LIGO-T080168-01-K

*Advanced LIGO*

16<sup>th</sup> July 2008

Concepts for the Gold Barrel Sleeve for both the ETM  
and TCP Optics

## 6 Drawing reference

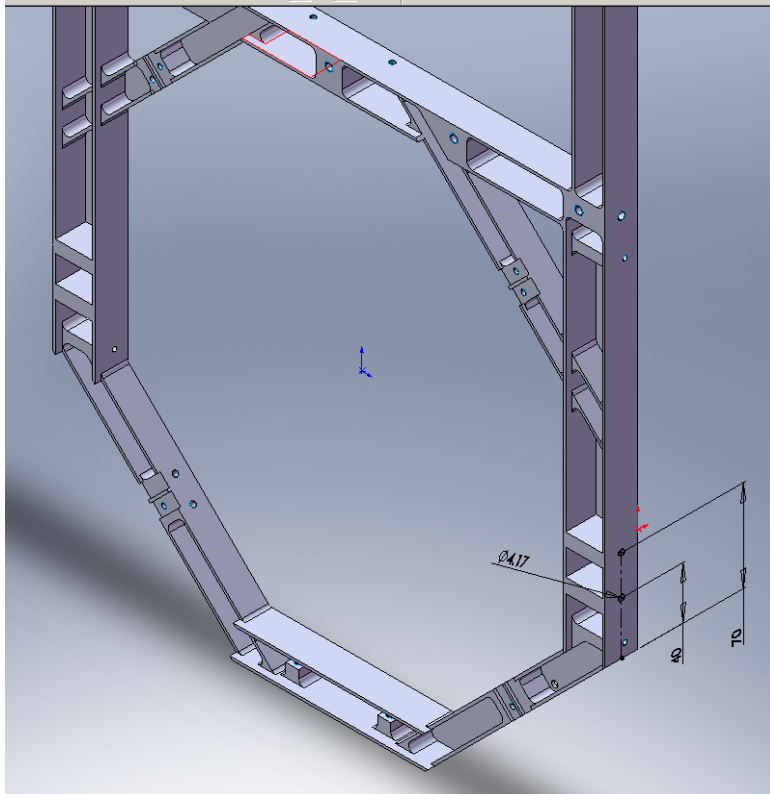
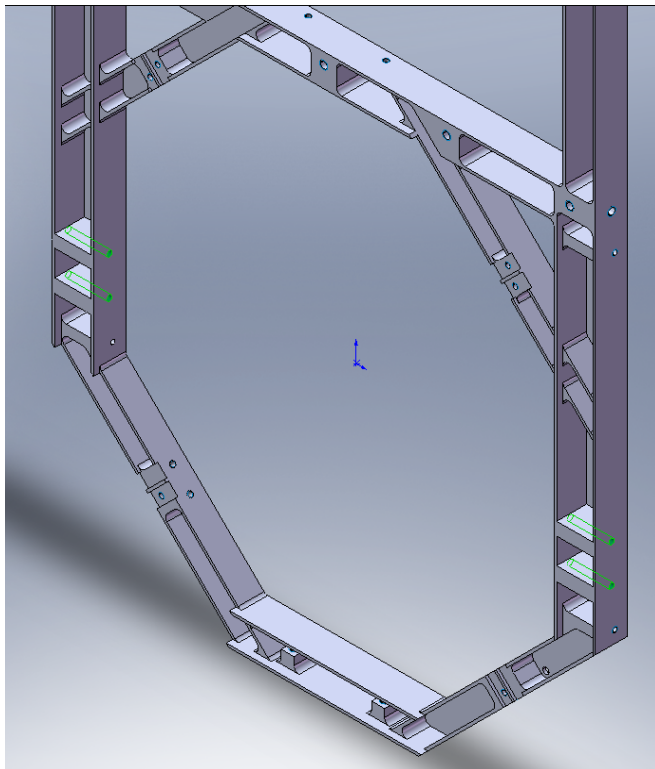
We are asking RAL to consider adding an additional 4x 8-32 tapped holes with appropriate material and Heli-coils to each of the 2 face plate designs, LIGO-D060434 and LIGO-D060462, refer to section 6 below. (The numbers in section 6 are 40 mm and 70 mm from end of the flat section of the face plate, as shown.)

It is assumed that these 4 additional holes will be added to each of the 2 face plates making up the lower structure (2x D060434 and 2x D060462).

Drawings LIGO-D060462-C and LIGO-D060434 are updated for the additional hole for the barrel. These are now released to the manufactures.
